**Before the Board of Supervisors in and for the  
County of Monterey, State of California**

**Resolution No. 12-038**

Resolution of the Monterey County Board of )  
Supervisors approving modification to )  
Combined Development Permit PLN100020 )  
(PLN120024)..... )

Modification (PLN120024) to previously approved Combined Development Permit (PLN100020) for York Highlands came on for public hearing before the Monterey County Board of Supervisors on February 7, 2012. Having considered all the written and documentary evidence, the administrative record, the staff report, oral testimony, and other evidence presented, the Monterey County Board of Supervisors hereby finds and decides as follows:

ILLUSTRATION OF  
HIGHWAY 218 ACCESS

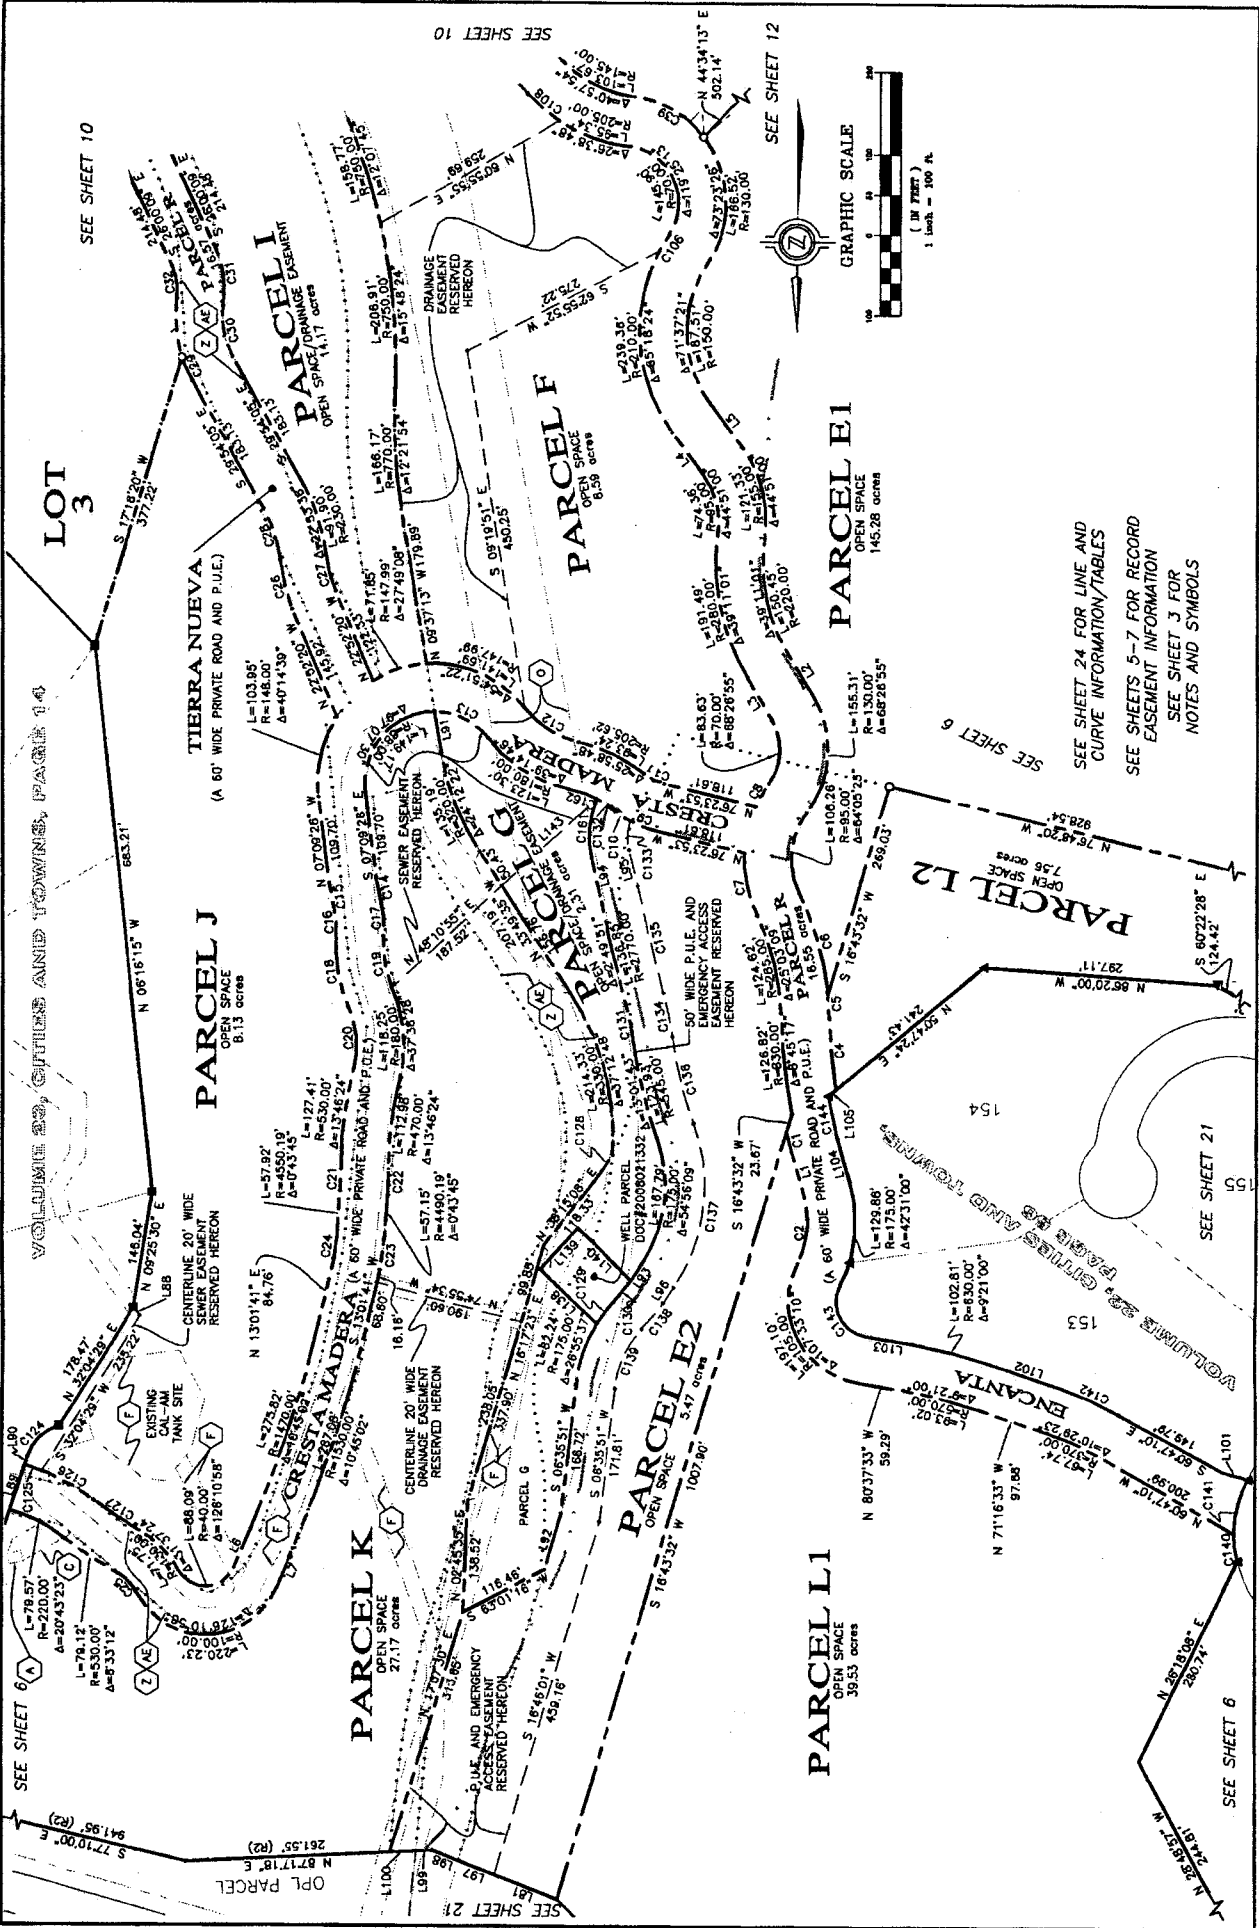
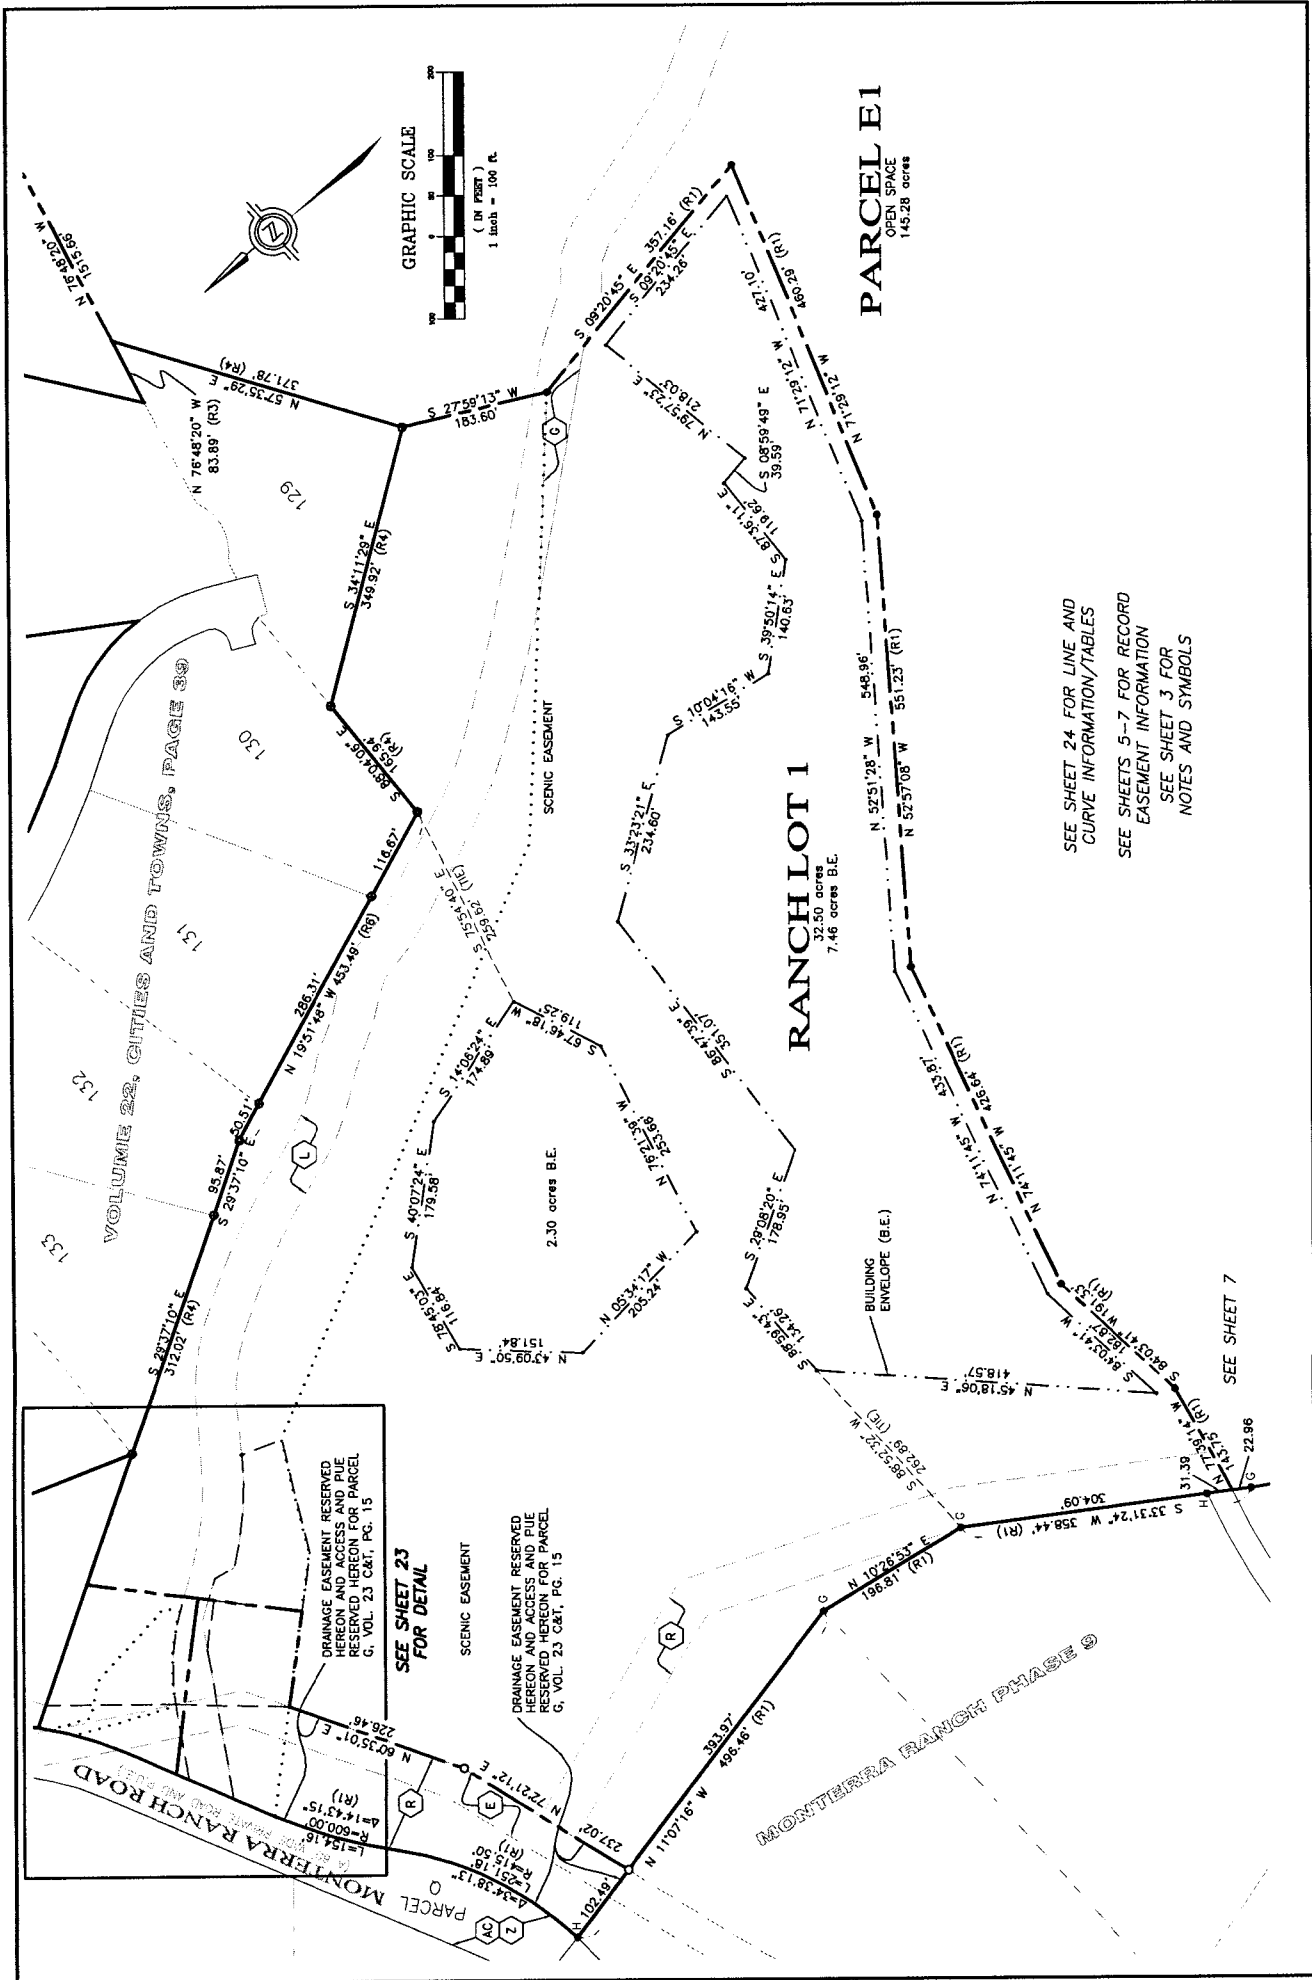
- f) The proposed modifications consist of: 1) change the access from York Highlands Road 1 to the existing Monterra Ranch Subdivision entrance at Highway 218; 2) re-designate the approximately 1,400 foot long section of York Highlands Road 1 between State Highway 68 and York Highlands Road 2 from a 60-foot wide road and utility easement to a 50-foot wide emergency access and public utility easement; 3) designate the 50-foot wide, approximately 1,200-foot long fire access road between Monterra Ranch Phase 6 and York Highlands as a 60-foot wide private road and public utility easement; 4) modify Condition No. 52 (Board of Supervisors Resolution No. 11-342) to eliminate the requirement for specific improvements to Highway 68 at the York Highlands Road 1 entrance; 5) delete Mitigation Measure No. 71; and 6) amend the vesting tentative map to create a 1.79-acre open space parcel (Parcel T), thereby reducing Ranch Lot 1 and to merge a 0.48 acre parcel with an existing well parcel to create one water utility parcel.

- m) This modification allows: re-designation of the approximately 1,400 foot long section of York Highlands Road 1 between State Highway 68 and York Highlands Road 2 from a 60-foot wide road and utility easement to a 50-foot wide emergency access and public utility easement; and designation of the 50-foot wide and approximately 1,200-foot long fire road between Monterra Ranch Phase 6 and York Highlands to a 60-foot wide private road and public utility easement. These changes will allow the use of the road that was previously designated for emergency access only for primary access and will limit access to the subdivision at York Road to emergency access only. This will allow residents to utilize the main Monterra Ranch access at Highway 218.
